# County of Fairfax, Virginia

## STAFF REPORT ADDENDUM II

### SPECIAL EXCEPTION AMENDMENT APPLICATION SEA 94-P-040

**APPLICANT:** RP MRP Tysons, LLC

PROPOSED DISTURBANCE OF 100' OFFSET OF EX. RPA LANDSCAPE RECORDED  
 LANDSCAPE RECORDED  
 OVERSTORY TREES (100 TREES/AC)  
 UNDERSTORY TREES (200 TREES/AC)  
 SHRUBS (200 PLANTS/AC)  
 LANDSCAPE (200 PLANTS/AC)  
 SHRUBS (200 PLANTS/AC)

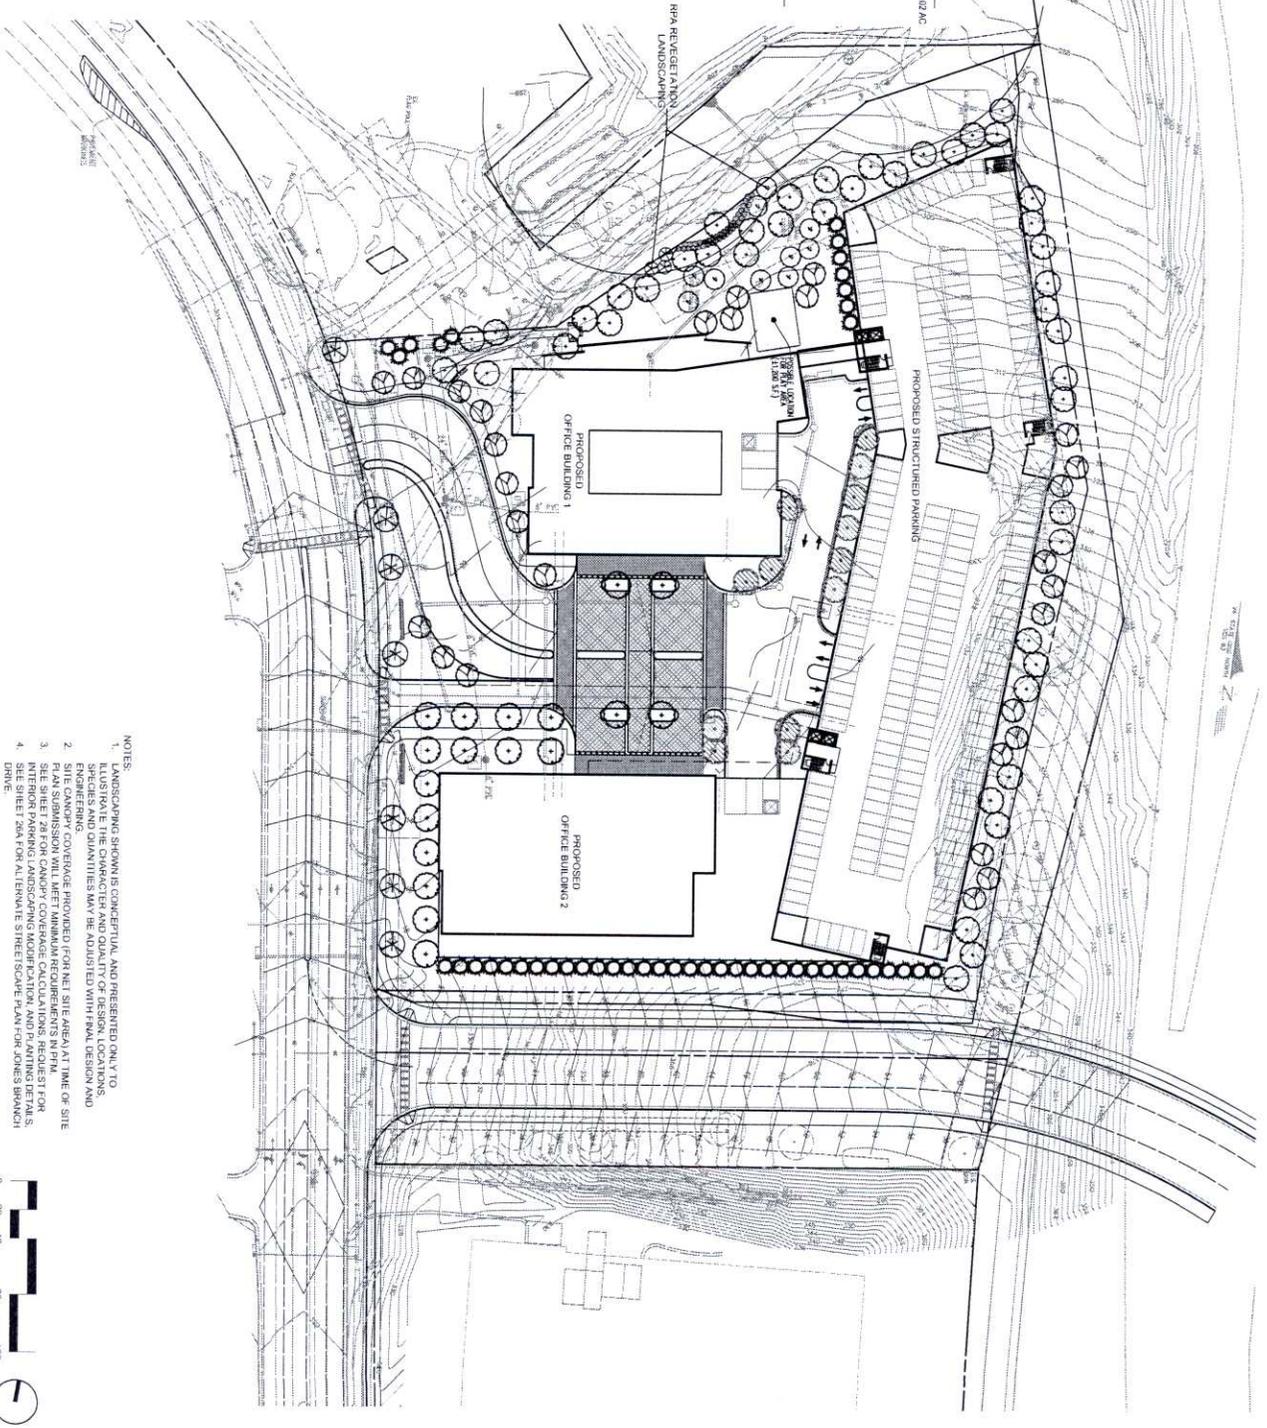
It should be noted that it appears from the SEA Plat that some of the plantings in Option 1 appear to be planted too close to a restrictive barrier. Staff advises the applicant that staff will review for adequate planting area to achieve landscaping sustainability during site plan review.
